**In the Matter of the Request for Annexation of 35.086 acres of land to the R-15 (Medium-high-density residential) zoning district; and Preliminary Plat consisting of 256 building lots and 25 common lots on 33.71-acres of land in the R-15 zoning district for Avani Neighborhood Subdivision, by Conger Group.**

**Case No(s). H-2023-0049**

<b>STAFF REPORT</b>	
<b>COMMUNITY DEVELOPMENT DEPARTMENT</b>

SUBJECT: Avani Neighborhood AZ, PP  
[H-2023-0049](#)

FIGURE 1

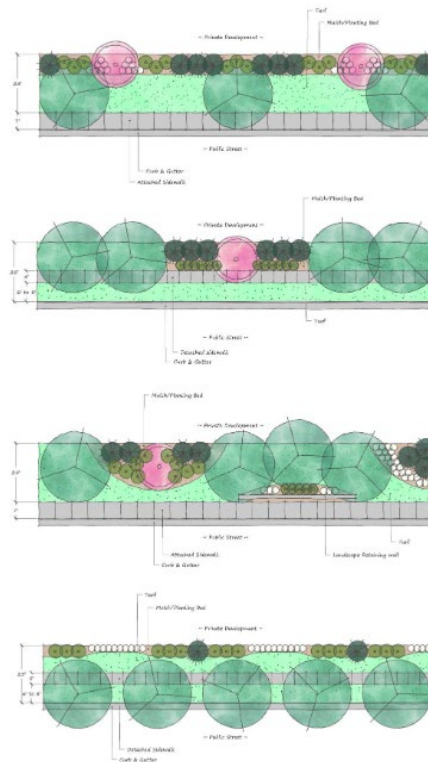
**Landscaping (UDC [11-3B](#)):** A 25-foot wide street buffer is required is required along all arterial streets (i.e. S. Black Cat Road) in residential districts. A 20-foot wide street buffer is required along all collector streets (i.e. Vantage Point Way) a collector street, per UDC [Table 11-2D-7](#), landscaped per the *updated* standards listed in UDC [11-3B-7C](#). **The proposed buffer along the southern half of Black Cat Road appears to be 20-feet in width and should be 25-feet in width. The 20-foot wide buffer along the new collector street (Vanguard Way) appears to meet the requirements of the UDC code; however, there is a lack of a combination of planters (shrubs and rock mulch) within both of the buffers (refer to the figures below).**

An 8-foot wide parkway with Class II trees is required along all local streets per UDC [Table 11-2D-6](#), landscaped per the standards listed in UDC [11-3B-7C](#).

C. Preliminary Plat (dated: 10/18/23) — **NOT APPROVED**

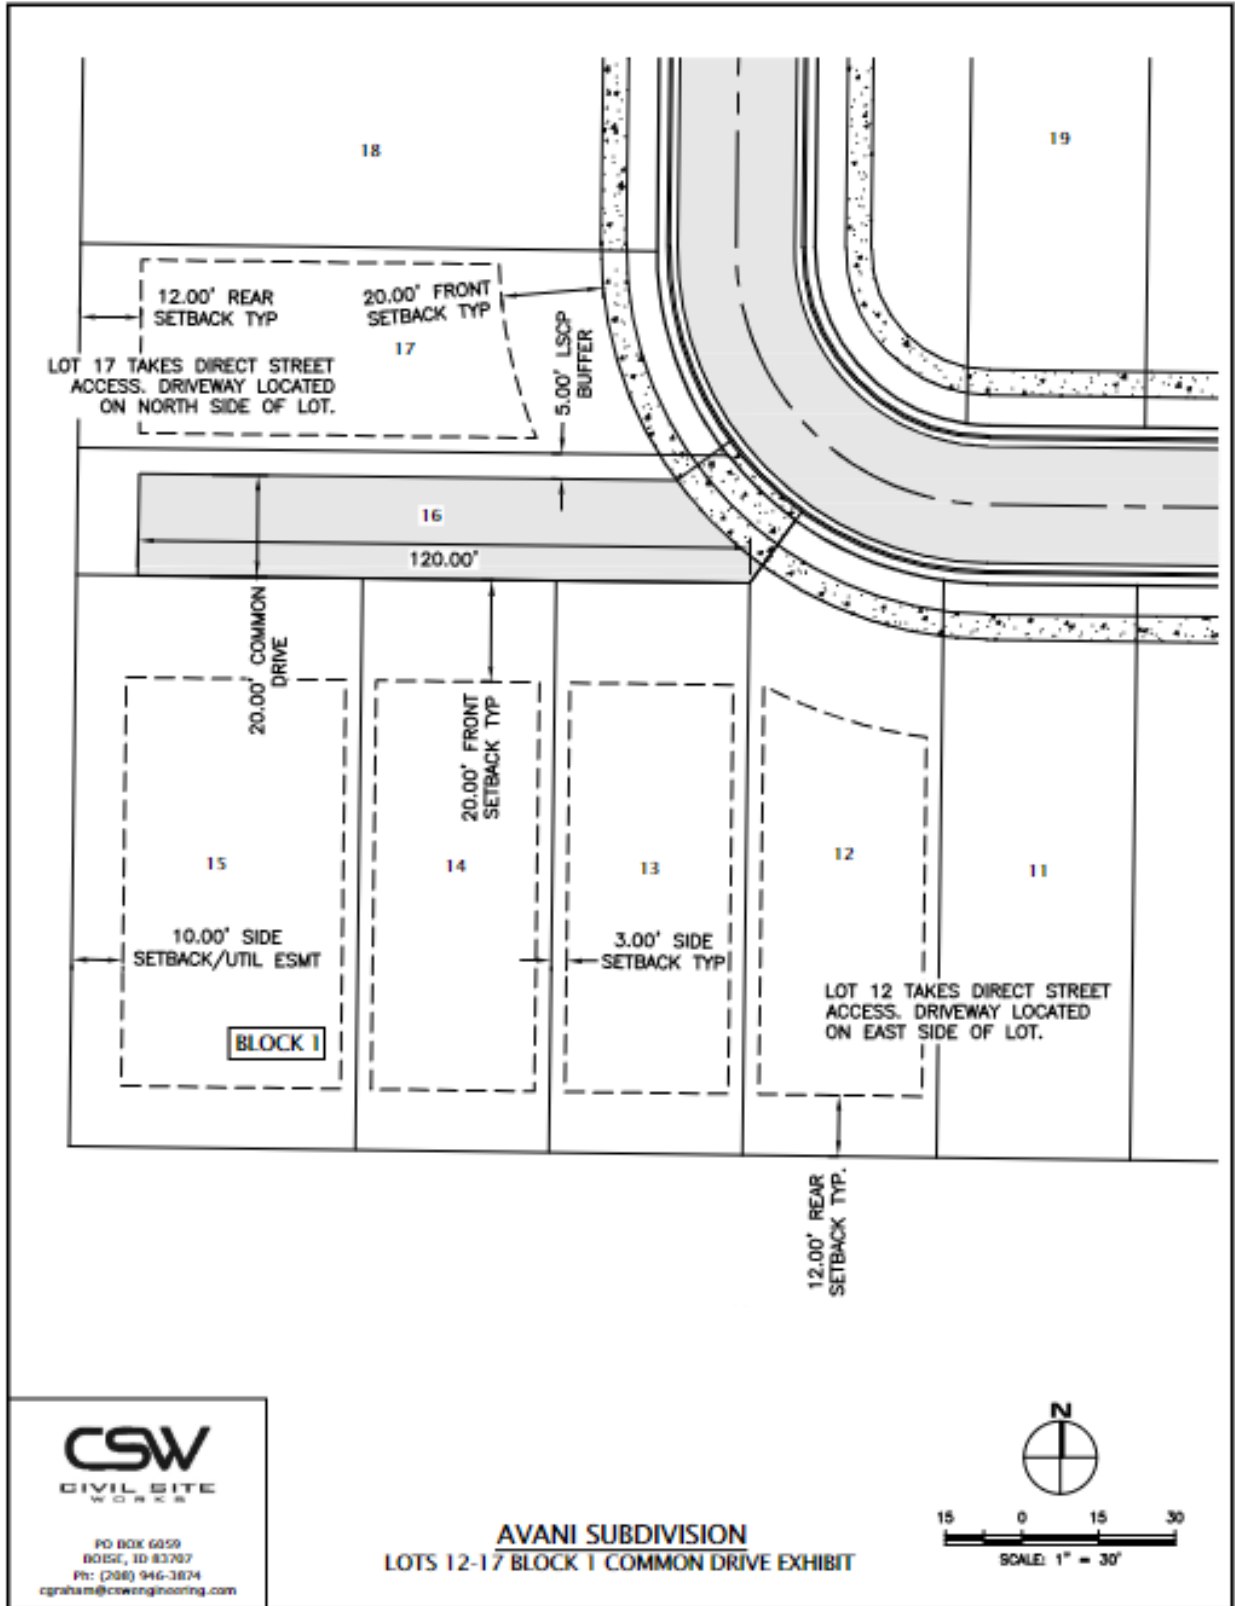
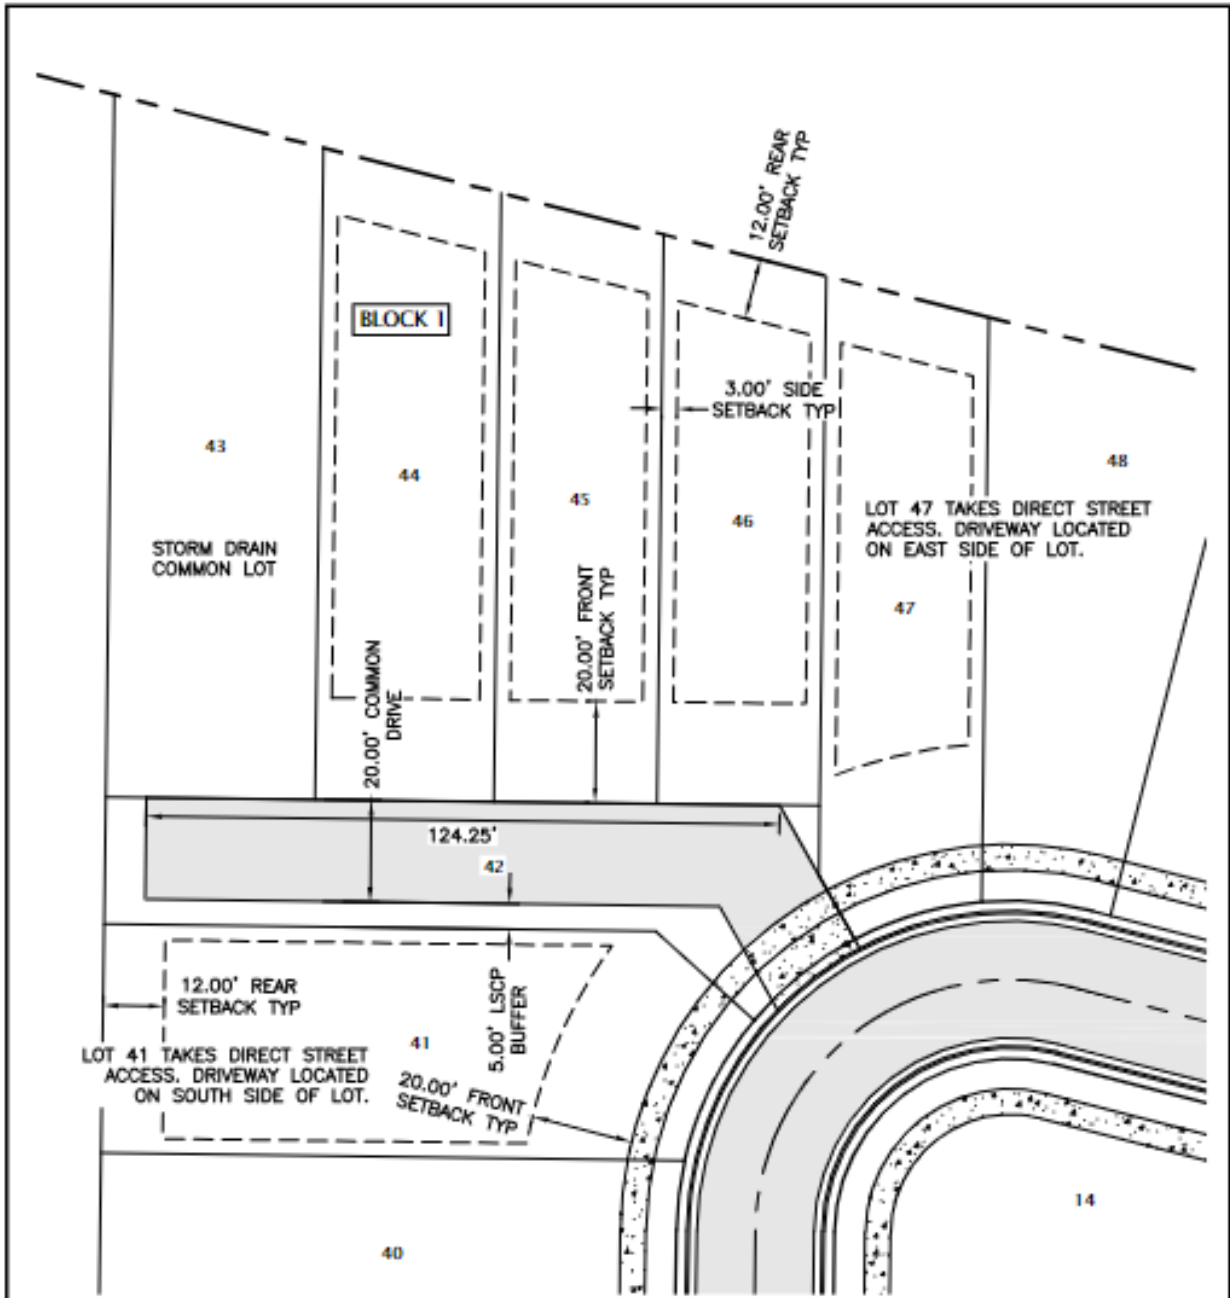
A preliminary plat is proposed consisting of 256 [95 single-family attached, 10 alley-loaded, and 151 single-family detached units] building lots and 25 landscape, six (6) common driveways, two (2) alleys, and one (1) non-buildable lot on 33.707-acres of land in the R-15 district. Proposed lots range in size

from 2,436 to 5,357 square feet (s.f.) with an average lot size of 3,584 (sf.) The subdivision is proposed to develop in three (3) phases as shown on the preliminary plat in Section VIII.C.

**Common Driveway (UDC [11-6C-3D](#)):** Six (6) common driveways are proposed within the development of the site on Lot 42, Block 1, Lot 16, Block 1, Lot 41, Block 2, Lot 33, Block 2, Lot 16, Block, 2, and Lot 23, Block 5. Common driveways are allowed to serve a maximum of four (4) dwelling units; in no case shall more than three (3) dwelling units be located on one (1) side of the driveway. **A total of four (4) dwelling units are proposed on the south side of driveway for Lot 23, Block 5; the final plat and common driveway exhibit shall be revised to depict a maximum of three (3) units on one (1) side of the driveway as required; or, alternative compliance may be requested as set forth in UDC [11-5B-5](#).**

2. The final plat shall include the following revisions:
  - a. Include a note prohibiting direct access via S. Black Cat Road and Vanguard Way.
  - b. Depict street sections for Vanguard Way consistent with Street Section C in the TMISAP with a modification that allows (3) 11-foot travel lanes, 8-foot parkways and detached 10-foot wide sidewalks/pathways in lieu of on-street bike lanes as required by ACHD. Streetlights are required at a pedestrian scale, unless another alternative is approved (see pg. 3-20, 3-22, 3-23).

**AVANI SUBDIVISION**  
**LOT 41-47 BLOCK I COMMON DRIVE EXHIBIT**

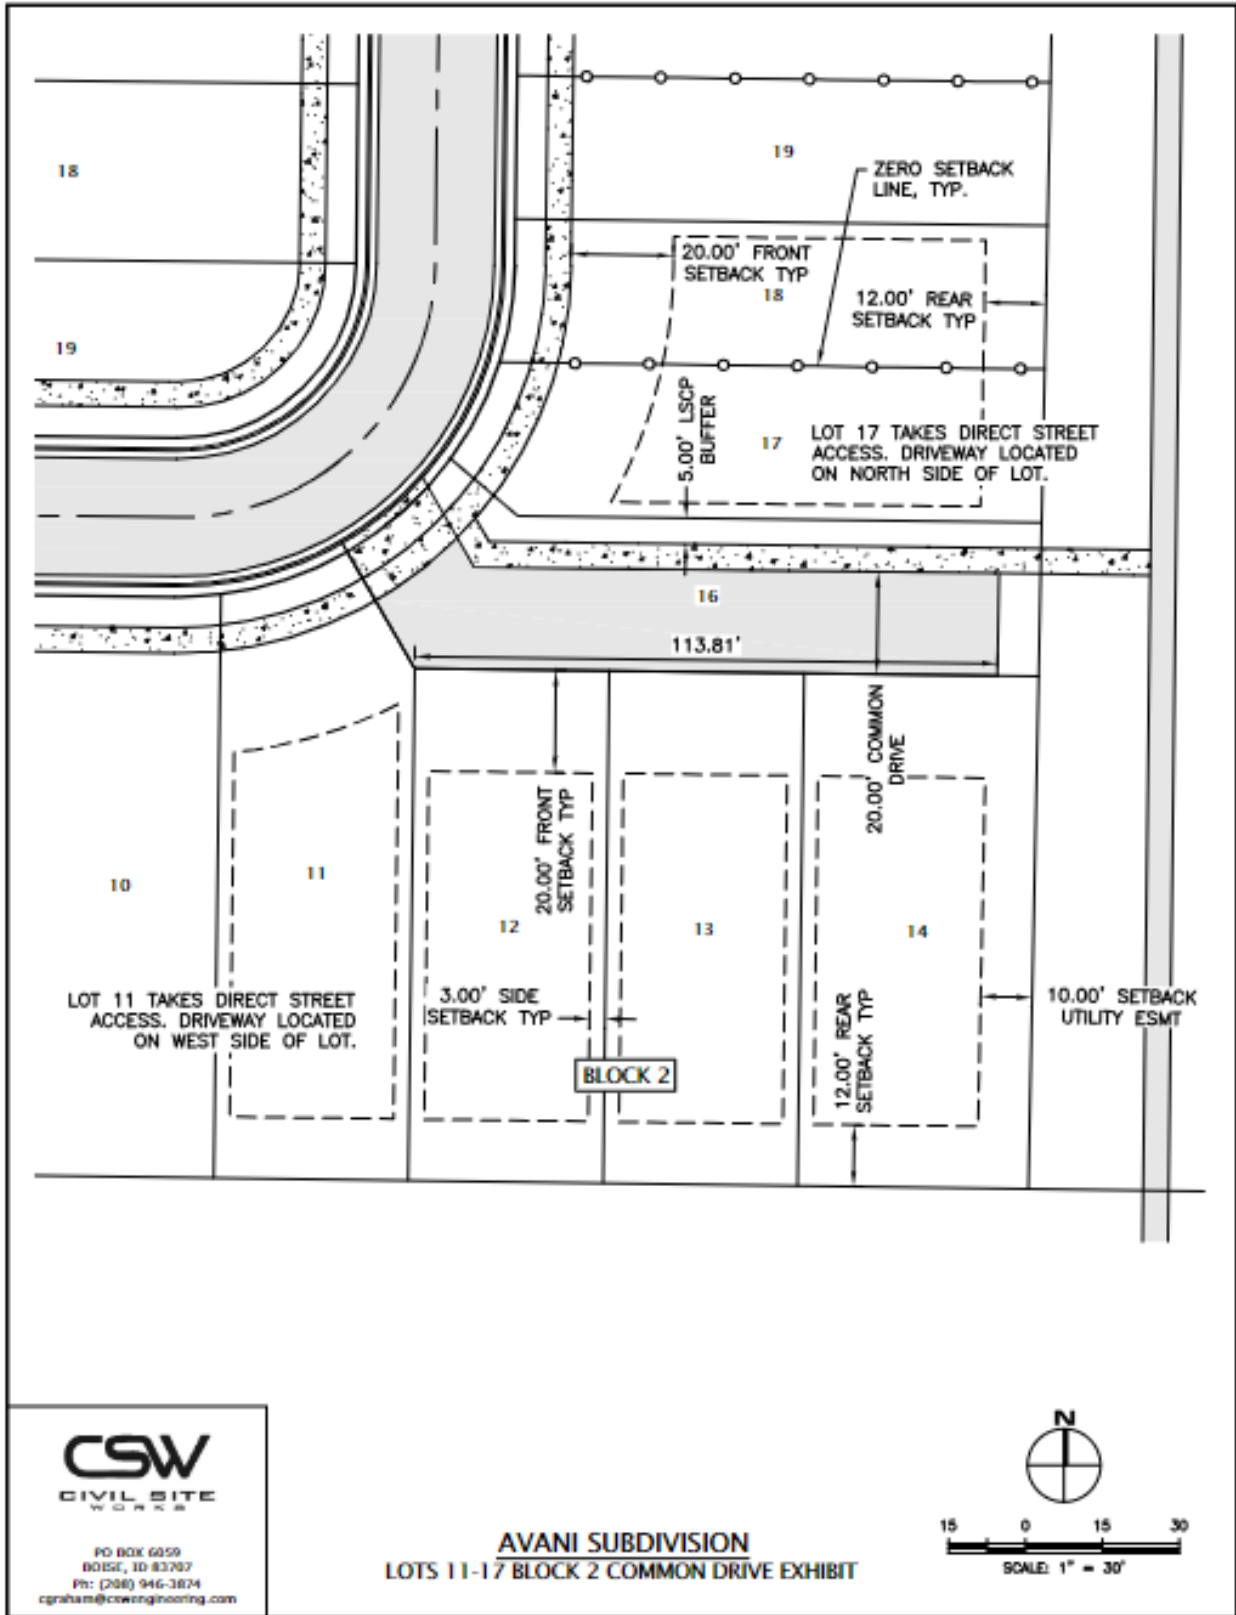
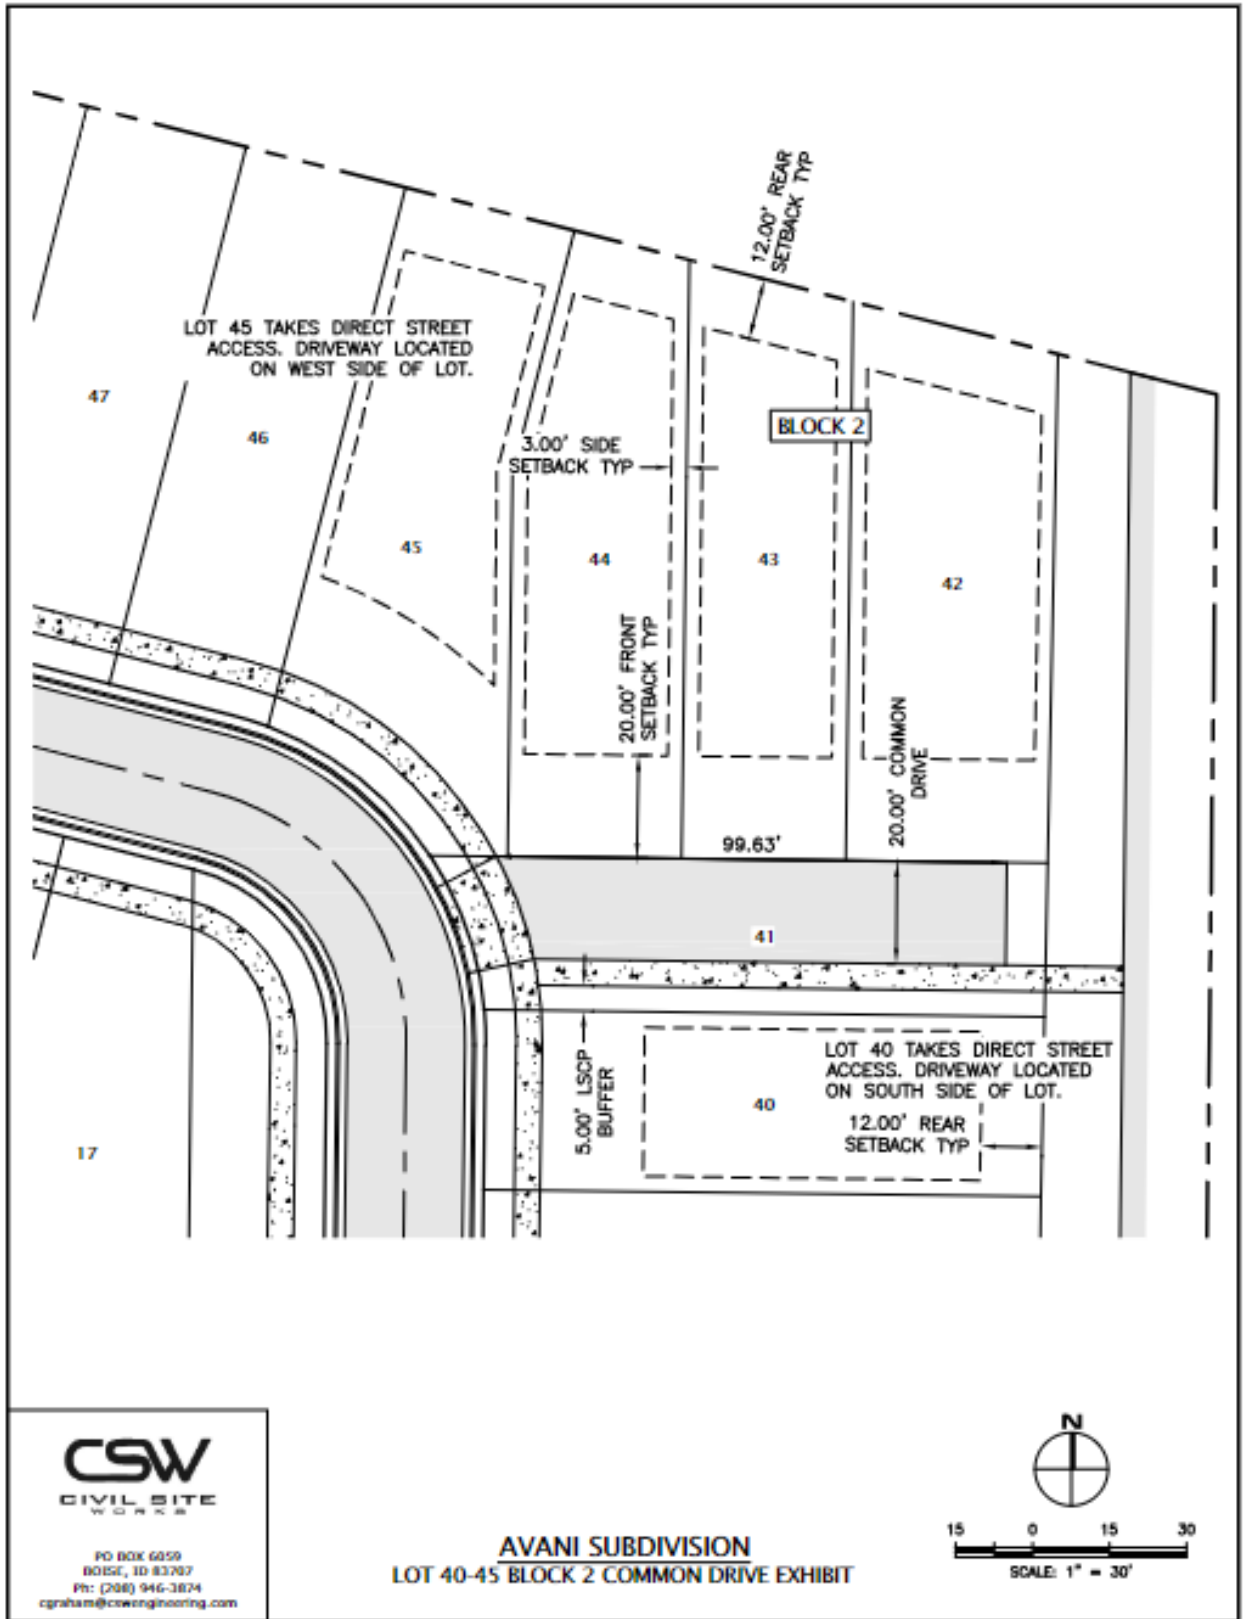
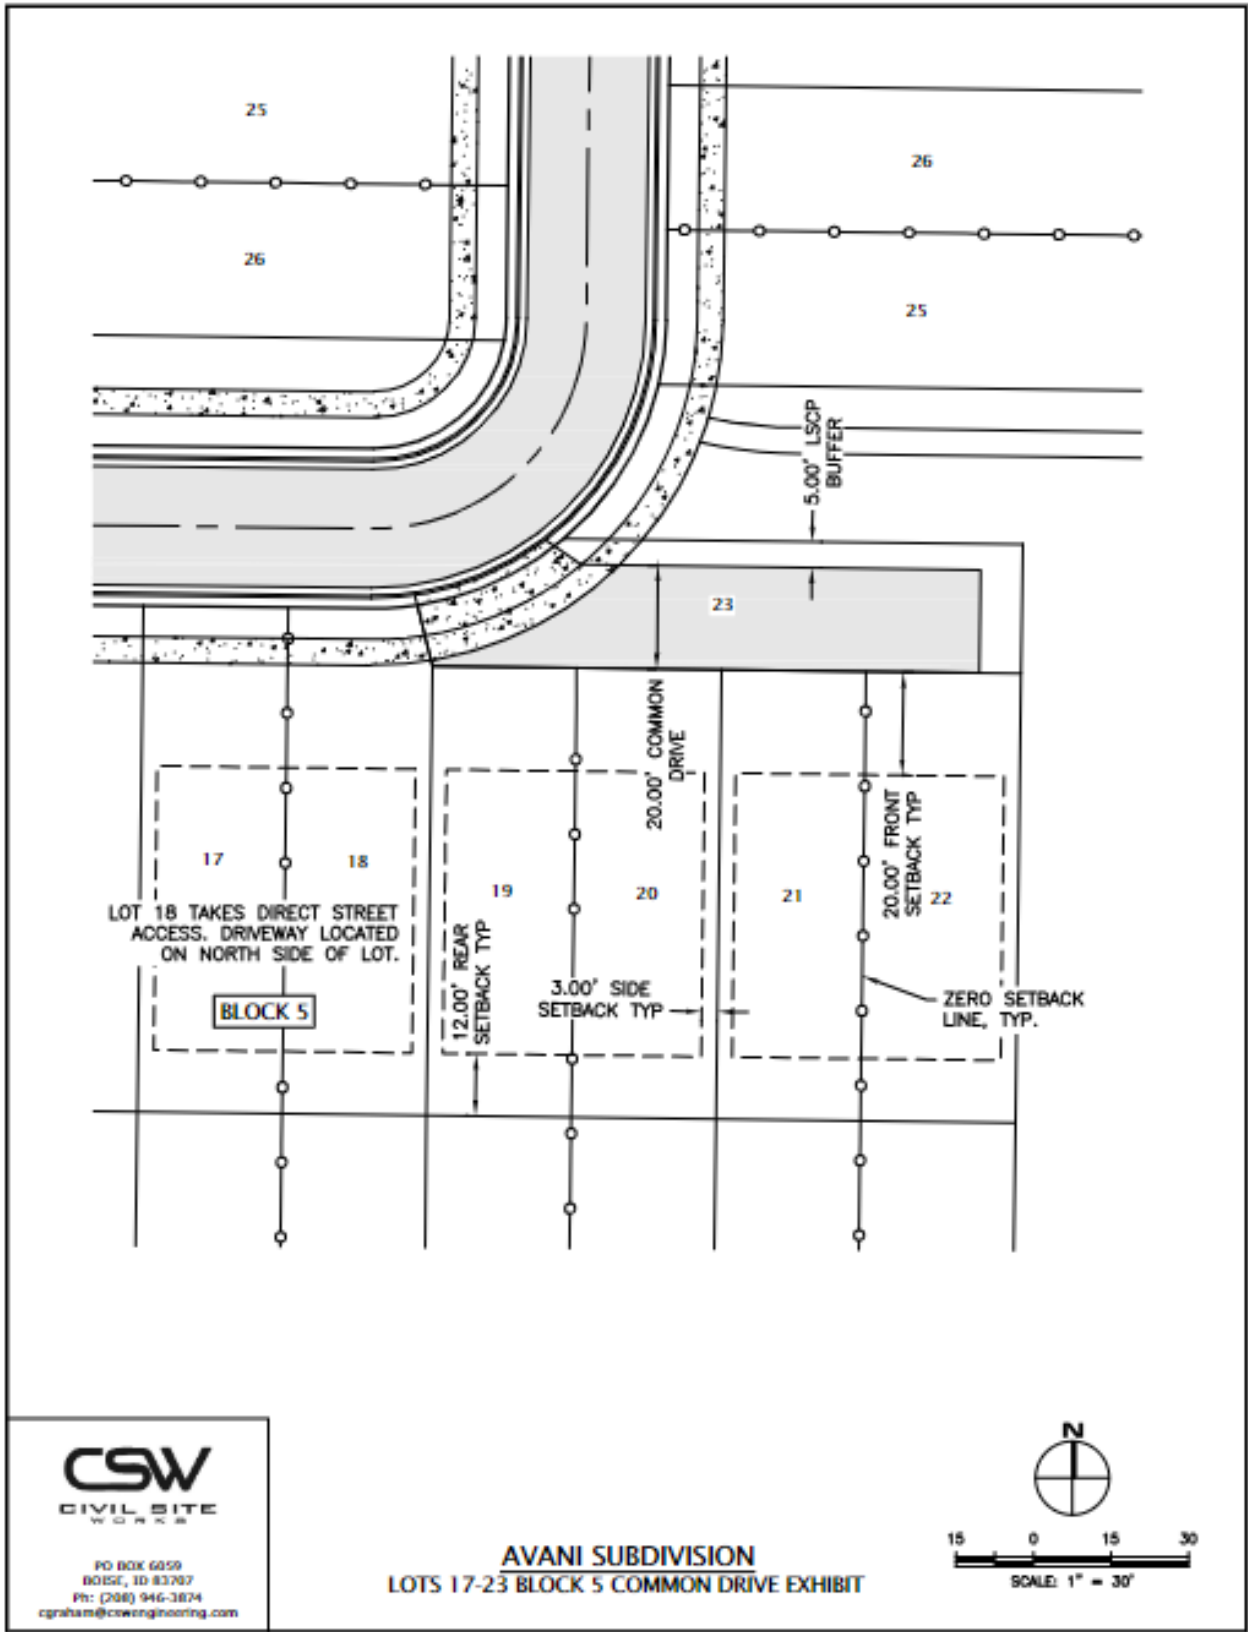
A perpetual ingress/egress easement is required to be filed with the Ada County Recorder for the common driveway, which shall include a requirement for maintenance of a paved surface capable of supporting fire vehicles and equipment. **This may be accomplished through the depiction of the easement on the face of the final plat and an accompanying note. If a separate easement is recorded, a copy should be submitted to the Planning Division with the final plat for City Engineer signature.**

D. Common Drive Exhibit —*NOT APPROVED*
